DOMINION NUCLEAR CONNECTICUT, INC.
MILLSTONE POWER STATION UNITS 2 AND 3
LICENSE AMENDMENT REQUESTS (LBDCR 04-MP2-015, LBDCR 04-MP3-014)
ADMINISTRATIVE CHANGES IN TECHNICAL SPECIFICATIONS

LICENSE AMENDMENT REQUEST (LBDCR 04-MP2-015)
ADMINISTRATIVE CHANGES TO TECHNICAL SPECIFICATIONS

MILLSTONE POWER STATION UNIT 2
DOMINION NUCLEAR CONNECTICUT, INC.

FIGURE 3.4-1

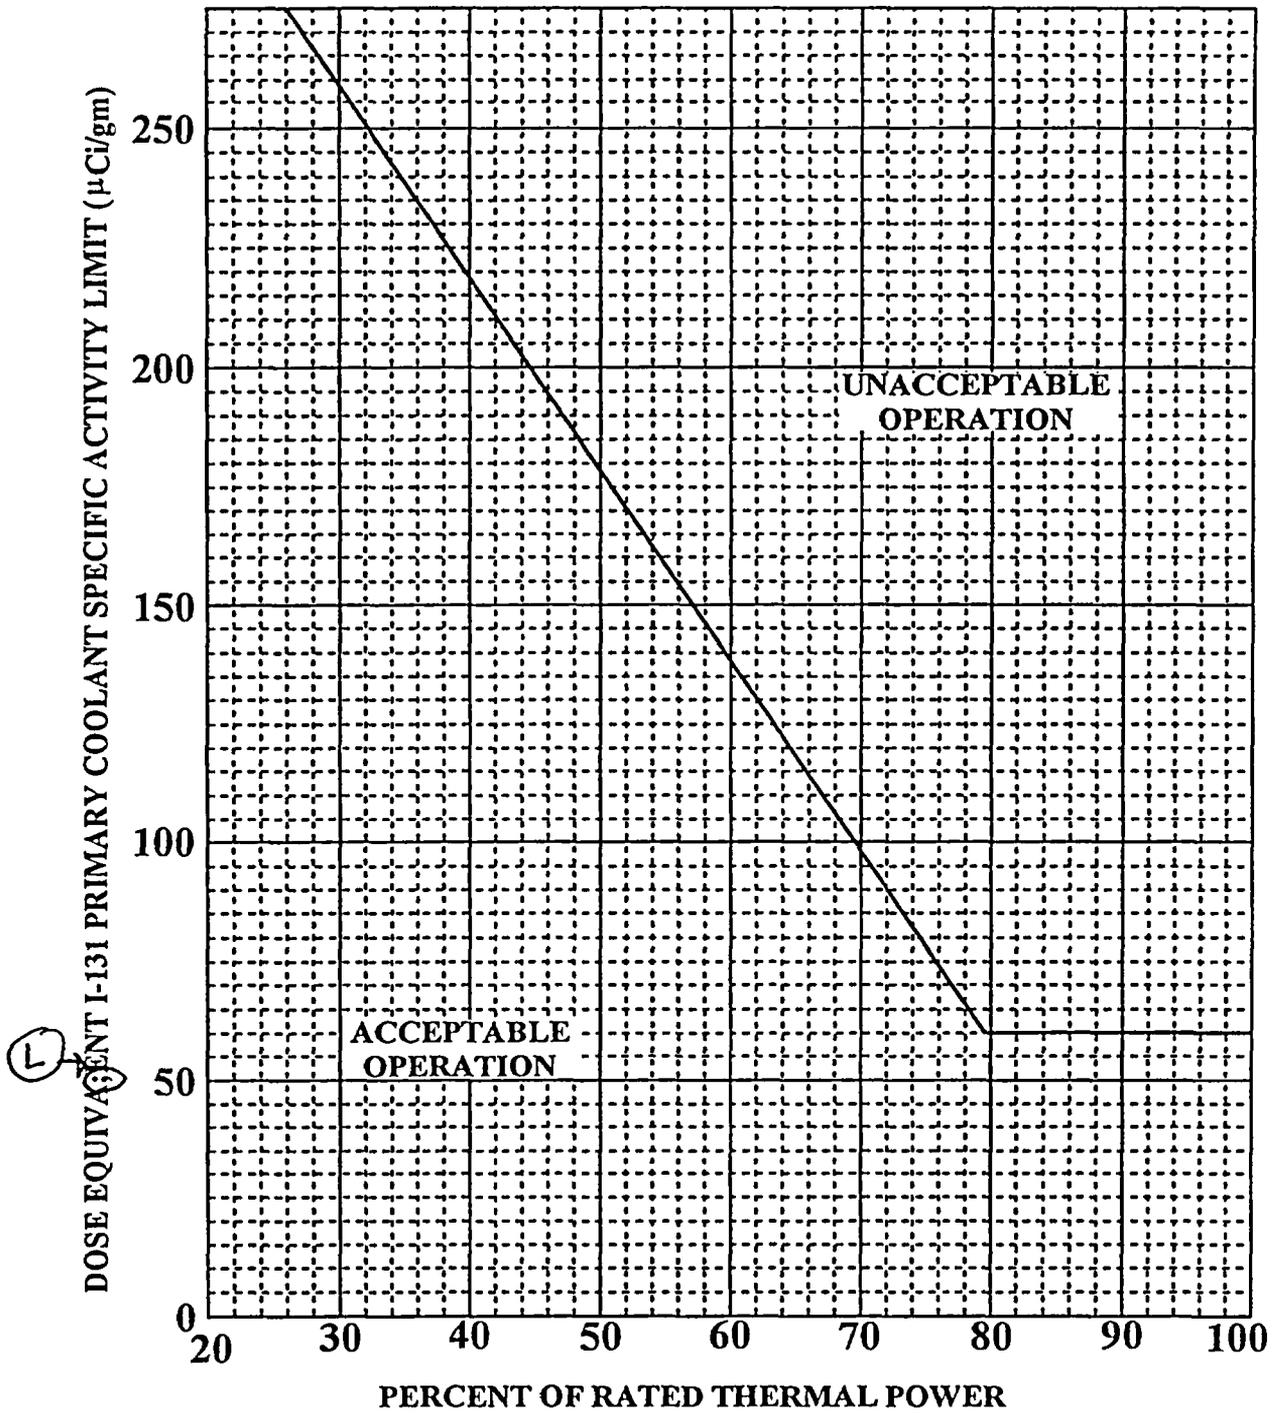
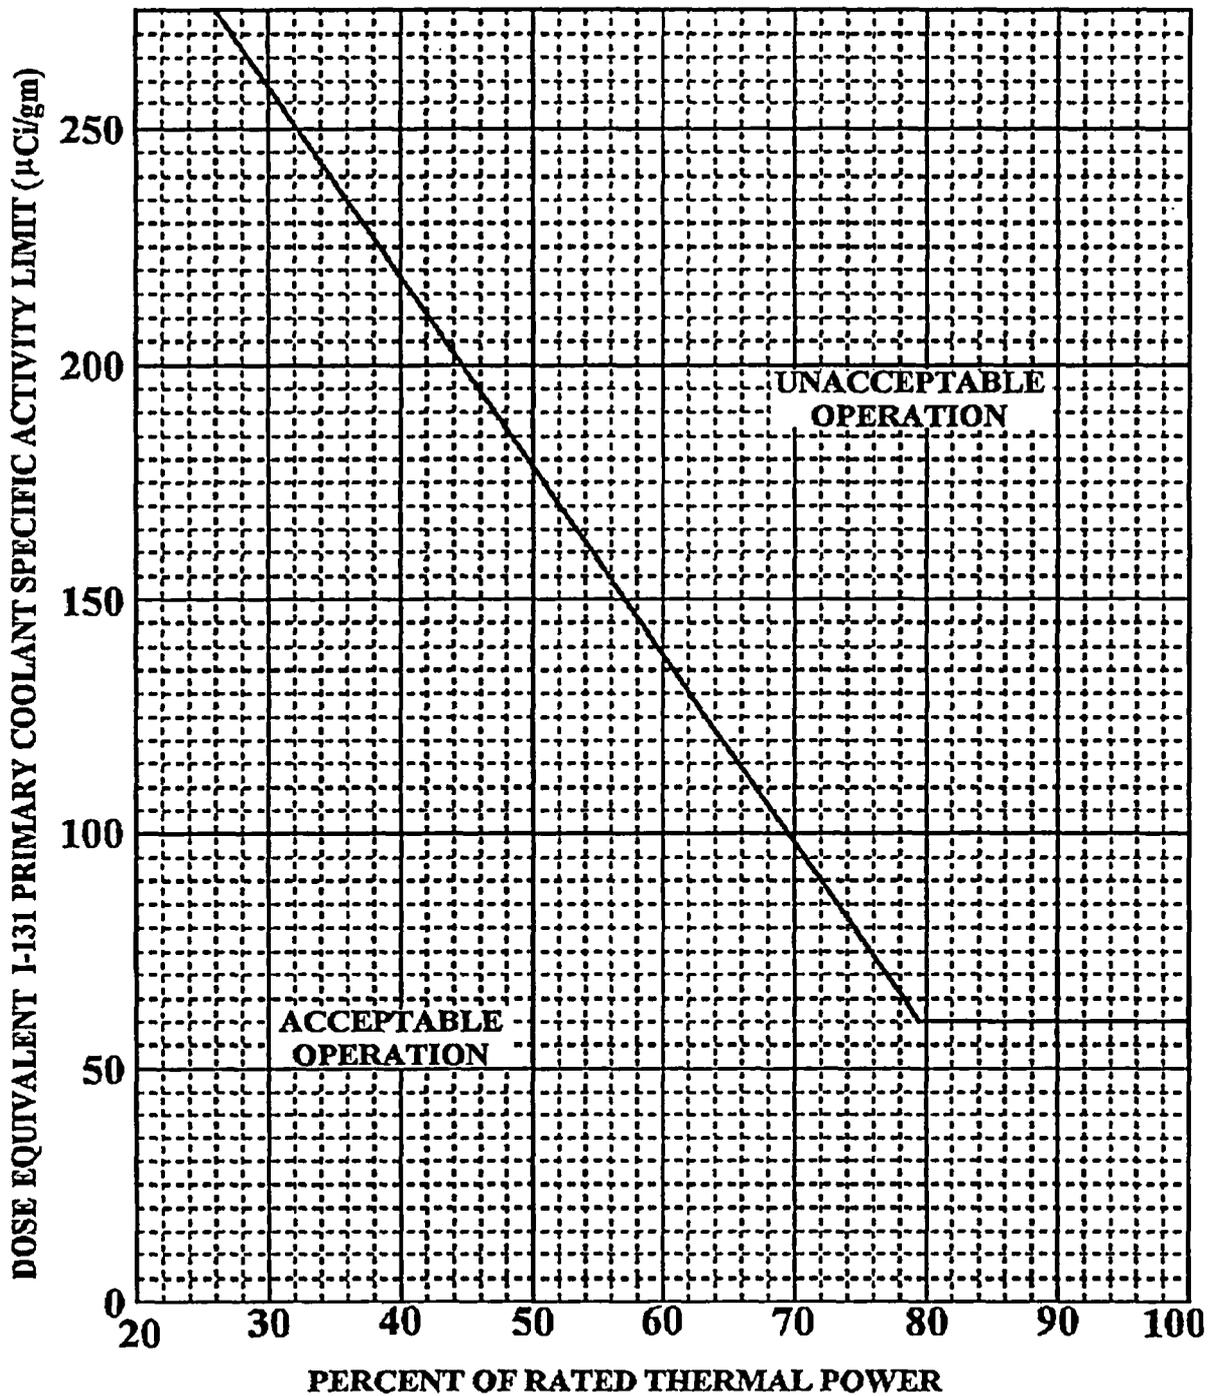
15. Page 3/4 4-16: Capitalize the term "DOSE EQUIVALENT."
16. Page 3/4 6-12: Capitalize the term "ACTION."
17. Page 3/4 7-9b: Capitalize the term "ACTION" and add titles at top of page.
